TRANS/WP.29/839
23 January 2002

World Forum for Harmonization of Vehicle Regulations (WP.29)

DRAFT SUPPLEMENT 1 TO REGULATION No. 113

(Headlamps emitting a symmetrical passing beam)

"Annex 8

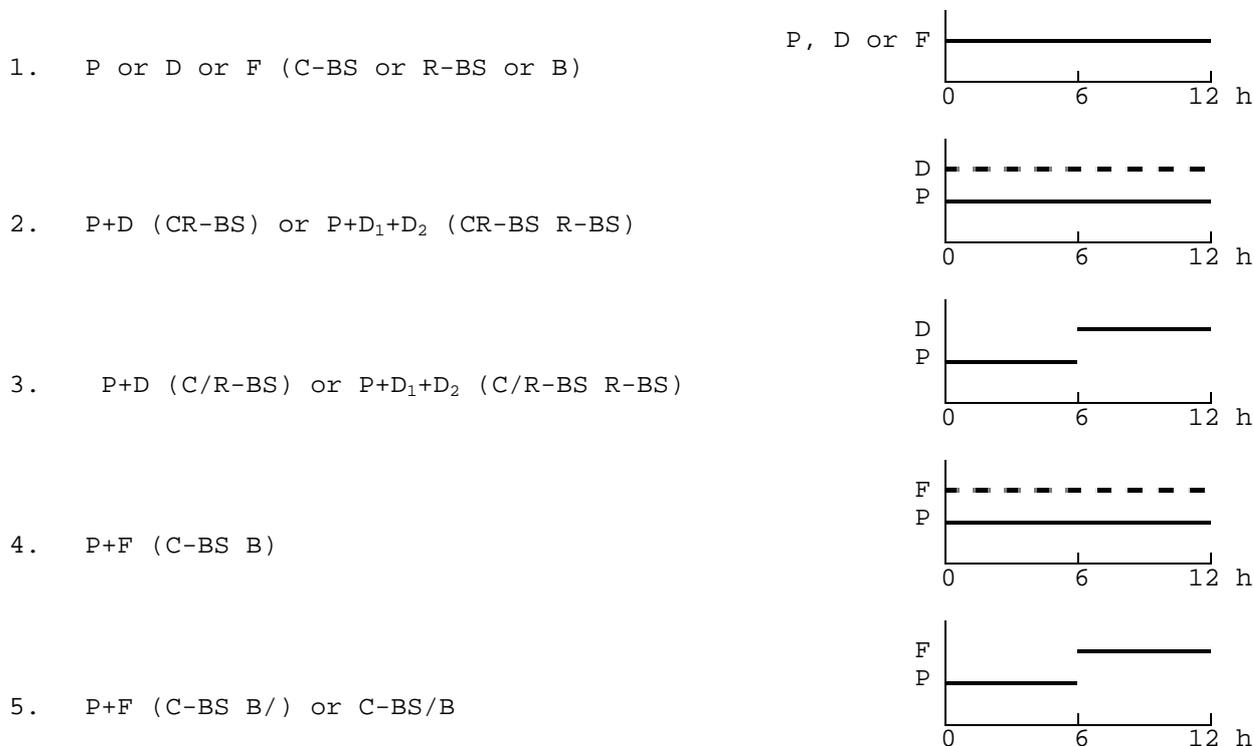
Add a new Annex 8, to read:

OVERVIEW OF OPERATIONAL PERIODS
CONCERNING TEST FOR STABILITY OF PHOTOMETRIC PERFORMANCE

- Abbreviations: P: passing beam lamp
D: driving beam lamp (D₁ + D₂ means two driving beams)
F: front fog lamp
- - - - - : means a cycle of 15 minutes off and 5 minutes lit.
